APPLICATION NO.	FILING DATE	FIRST NAMED INVENTOR	ATTORNEY DOCKET NO.	CONFIRMATION NO.
10/565,469	01/19/2006	Tobias Melz	1033832-000013	9936
21839 7590 09/12/2007 BUCHANAN, INGERSOLL & ROONEY PC POST OFFICE BOX 1404 ALEXANDRIA, VA 22313-1404			EXAMINER NGUYEN, XUAN LAN T	
			ART UNIT 3683	PAPER NUMBER
			NOTIFICATION DATE 09/12/2007	DELIVERY MODE ELECTRONIC

Office Action Summary

DETAILED ACTION

第 3 図

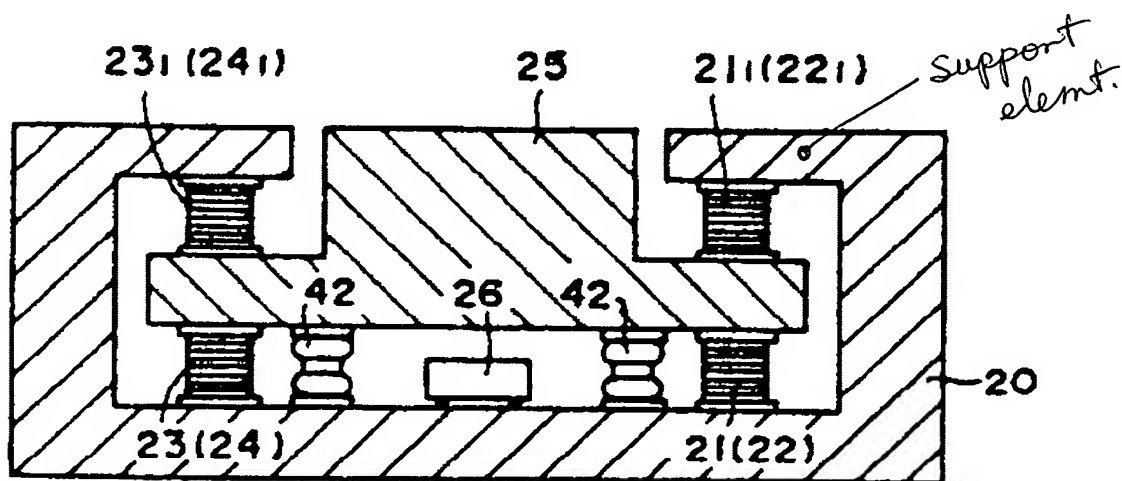
Re: claim 10, Katsumi shows an interface for reducing mechanical vibrations, as in the present invention, which has a base connection element 20, a load connection element 25 and at least one support element, as marked below, a) wherein at least a first energy converter system, 21, 23 bottom, extends between at least one engagement point located on the base connection element and at least one engagement point located on the load connection element; b) wherein at least one second energy converter system, 21, 23 top, extends between at least one engagement point located on the support element and at least one engagement point located on the load connection element; and d) wherein the load connection element 25 has a part located in an intermediate space between the base connection element and the support element, and a part located outside the intermediate space between the base connection element and the support element, as shown in figure 3. Katsumi lacks the elastic pipe surrounding the actuators as claimed. Sasaki shows an elastic pipe 14 for a vibration damper in figure 1 in order to provide further dampening capability to the

bearing body 13 at the same time to protect body 13 from environmental elements. It would have been obvious to one of ordinary skill in the art at the time the invention was made to have modified Katsumi's assembly to comprise an elastic pipe as taught by Sasaki in order to provide further dampening capability to the assembly of Katsumi at the same time protecting the assembly from environmental elements.
